MONTGOMERY COLLEGE PROCUREMENT DEPARTMENT

RFP NO.: 626-003

MACKLIN TOWER ROOF REPLACEMENT & LIMITED HVAC UPGRADES, ROCKVILLE CAMPUS RFP CLOSING DATE/TIME: SEPTEMBER 23, 2025 @ 2:00 PM

ADDENDUM #1

Drawing
DOOR SCHEDULE &
TYPES

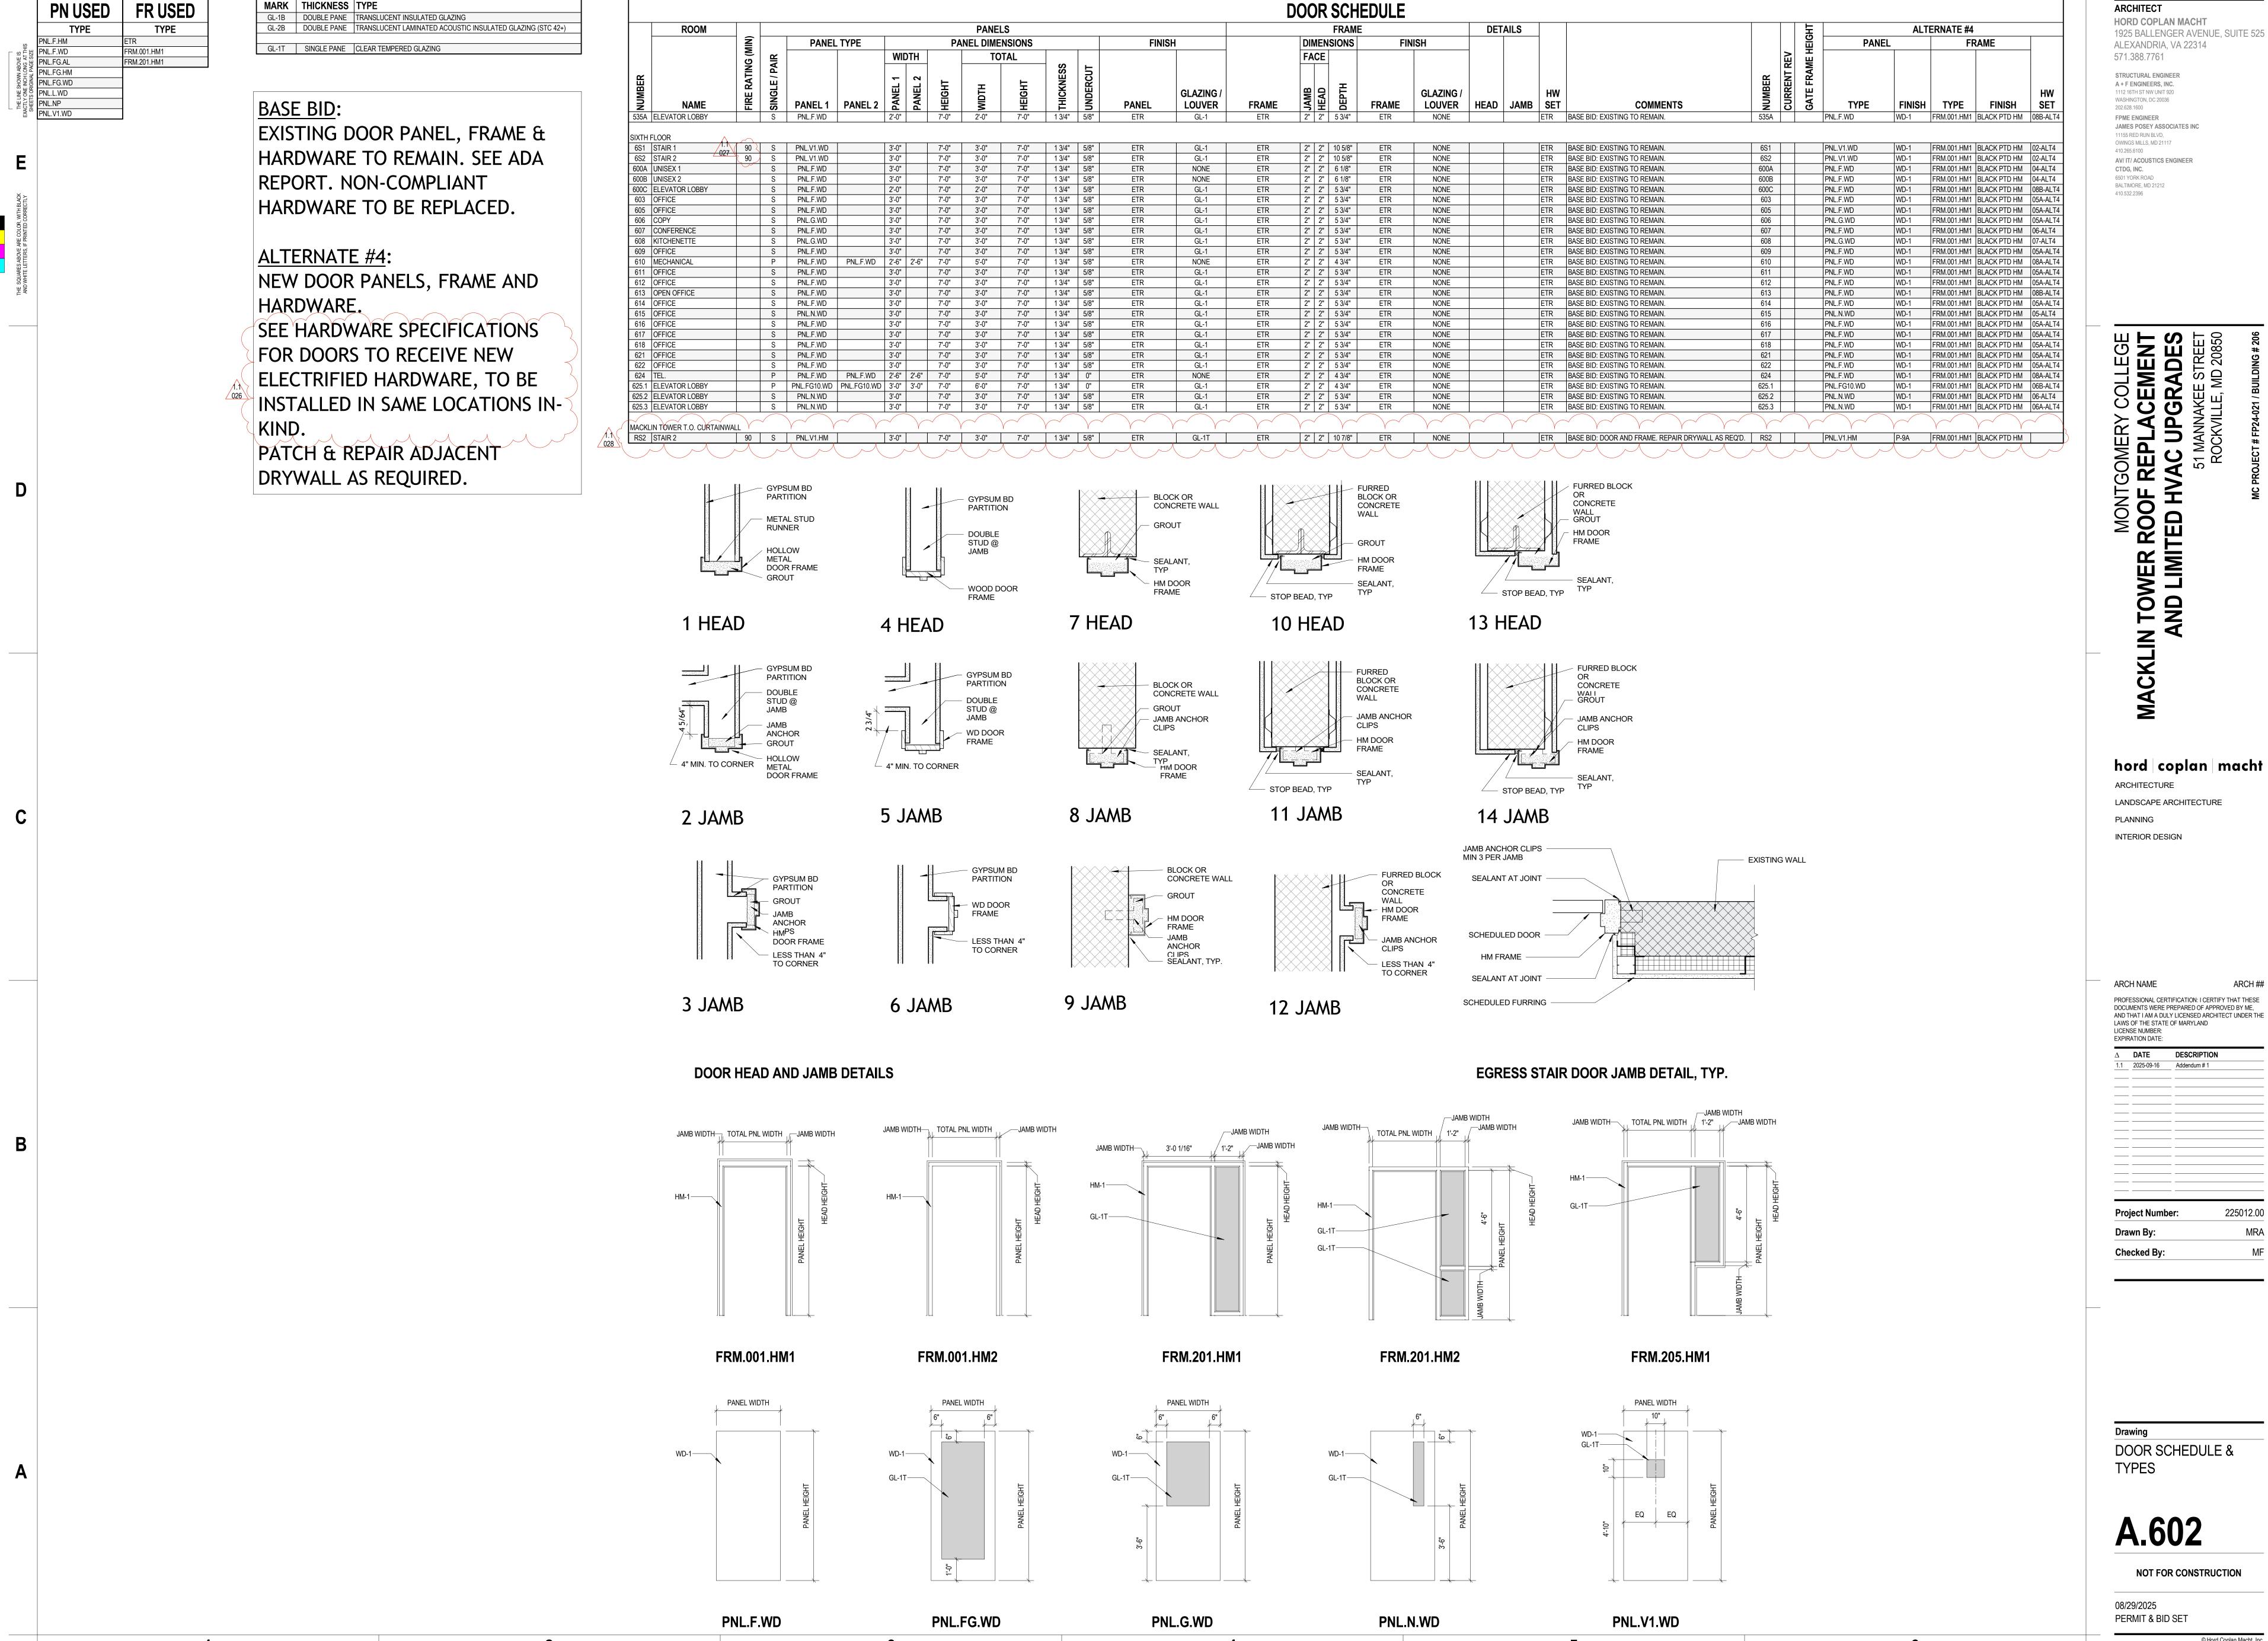
43	Verify new doors, frames, and hardware should be included in the base bid at doors 212C, 212D, 212E, & 212F. Door schedule states "Base Bid: Door and Frame" but does not indicate new hardware. Verify sets 05A-ALT4 should be included as part of the base bid.	Confirmed, Doors 212C, 212D, 212E & 212F shall be replaced as part of the base bid. Base bid scope will be identical to alternate (See A.402). 05A-ALT4 confirmed for hardware in both Base & Alternate. Door schedule will be updated with Addendum.
44	The door schedule does not show any of the Alternate #4 doors to be fire rated. Verify the stairwell doors & frames should have 90 min fire labels included in the alternate #4 pricing.	ALL STAIR 1 & 2 Doors shall be 90 min rated as part of Alternate #4. Schedule will be revised in Addnedum.
45	The door schedule shows the following door panel types with existing HM doors, but the Alternate #4 panel type shows them with wood doors. Verify these doors should be quoted as wood doors in Alternate #4 and not HM. 104A 104B 104C 214	Doors 104B & 104C are not on the schedule. Do you mean 104A, 140B & 140C? Scope clarification is as follows: Base Bid: All doors & frames to remain. Specific door hardware to be replaced where not ADA compliant (noted in scheduled comments & ADA report which will be provided) Alt #4: ALL DOORS, FRAMES & HARDWARE to be replaced. Frames to be PTD HM. Panels to be Wood (WD-1). Hardware to be per spec.

- A.602 DOOR SCHEDULES & TYPES
 - 1. Updated door schedule.
 - 2. Clarified Alternate #4 scope to include electrified hardware.
- M002 SITE PLAN DEMOLITION
 - 1. Corrected pipe size HS/HR size from 6" to 4".
- M003 SITE PLAN NEW WORK
 - 1. Corrected pipe size HS/HR size from 6" to 4".
- MD104 PART SECOND AND FOURTH FLOOR PLANS HVAC DEMOLITION
 - 1. Corrected tags specifying demolished duct and air devices as "ETR" to "RX".
 - 2. Removed errant empty room tag.
- E001 ELECTRICAL SYMBOLS AND ABBREVIATIONS
 - 1. Added symbol for demolishing fan-powered VAV.
- ED101 SECOND AND FOURTH FLOOR PLAN ELECTRICAL DEMOLITION
 - 1. Indicated fan-power VAV for demolition
- ED102 FIFTH AND SIXTH FLOOR PLAN ELECTRICAL DEMOLITION
 - 1. Indicated fan-power VAV for demolition
- E502 TELECOMMUNICATIONS GROUNDING DETAILS AND DIAGRAMS
 - 1. Removed general note "C".

MD104

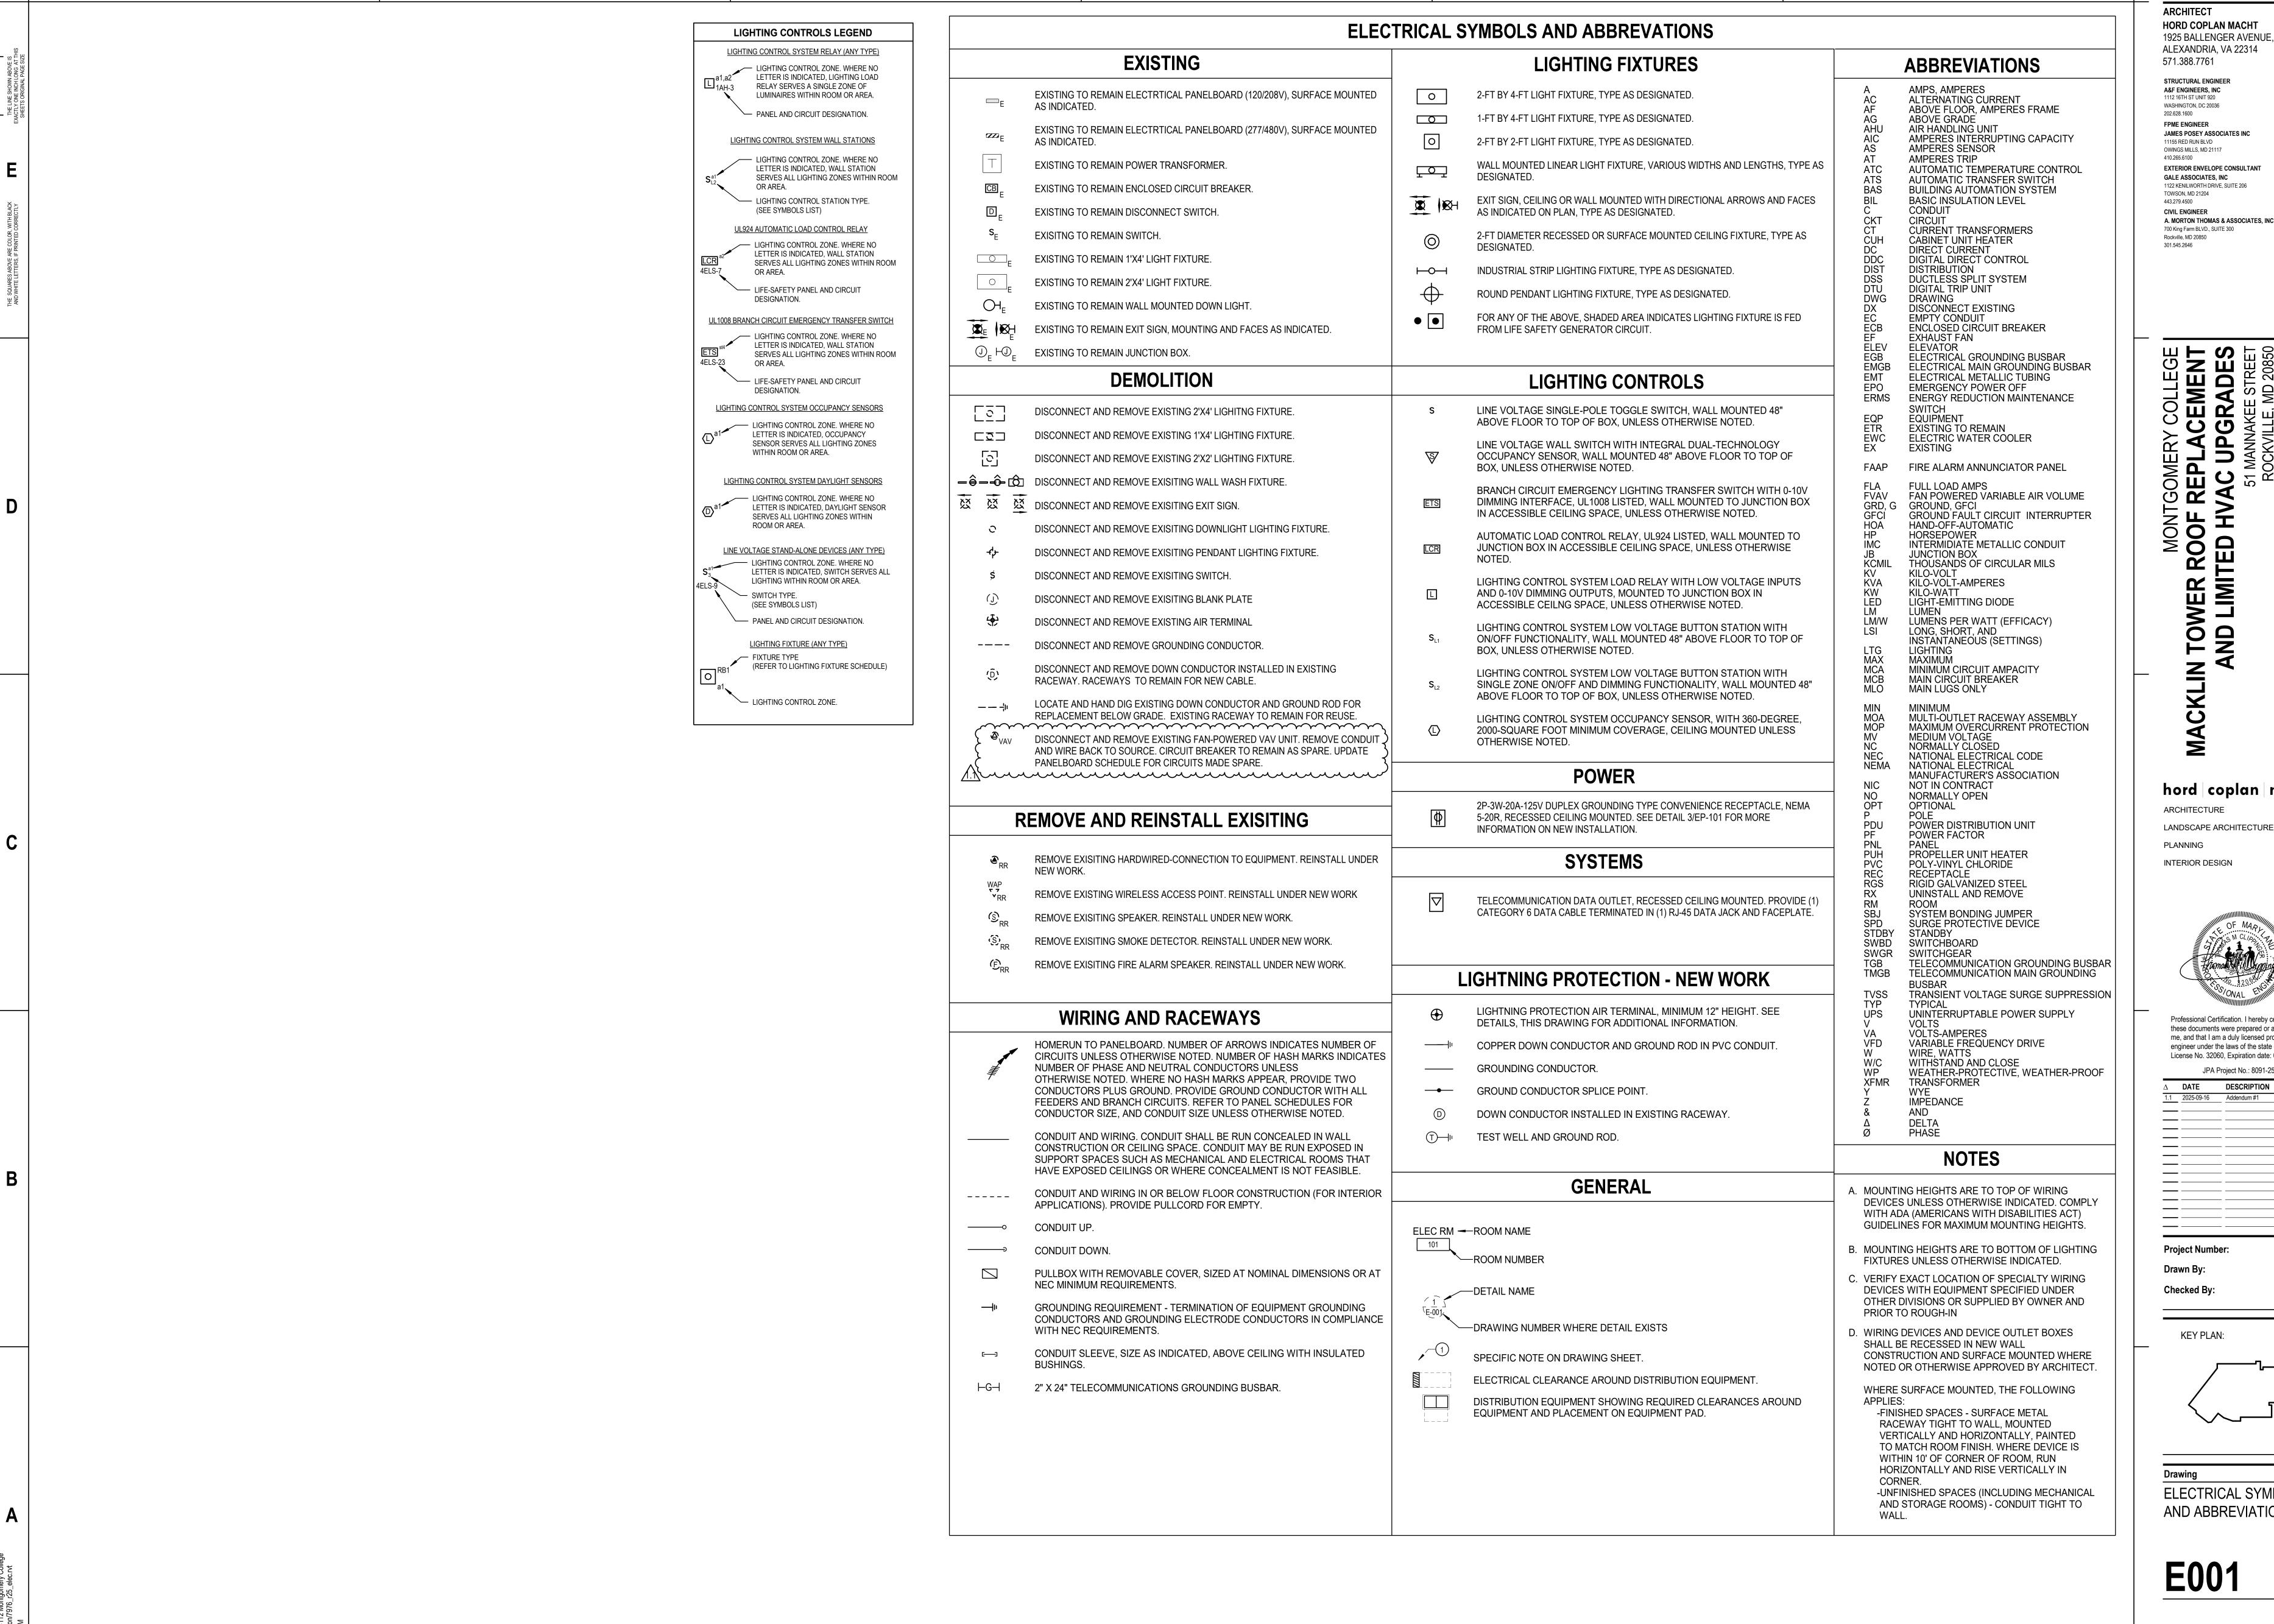
36	Drawing MD-104: Rm 212 indicates ETR SR and ETR SA however the ductwork is shown as a dash line. Please review and advise if this ductwork and accessories is to remain or it needs to be removed. If ductwork is to be removed, please update dwg AQ012 since the GWB Bulkhead is noted as ETR.	All ductwork and air devices associated with the VAV-2-6 unit should be domolished. GWB Bulkhead will need to removed and repaired as needed to accomodate this work.
37	Drawing E-502: General note C reads "See telecommunication drawings for additional information, equipment and requirements." – The only telecom drawing provided is E-502, please advise if additional telecom drawings will be provided. Please provide existing telecom drawing for the 6th floor, we would like to know the approx. location of the cable tray,	No additional telecom drawings are included. General note removed in Addendum #1.
38	Drawing MD-204: Existing FCUs are to be removed including piping which is located below the second floor. Be advised that 1st Floor Ceiling Plan does not show demolition or new ceilings. The 1st Floor ceiling will be impacted by the removal of the 2nd FL FCUs located in Rms 212F, 212E, 212D, 212C and 212B.	Level 1 Ceiling partial demolition & repair shall be included as part of Alternate #1 notes in Library project (FP-24-003). Coordination shall take place between contractors to prevent scope gap.
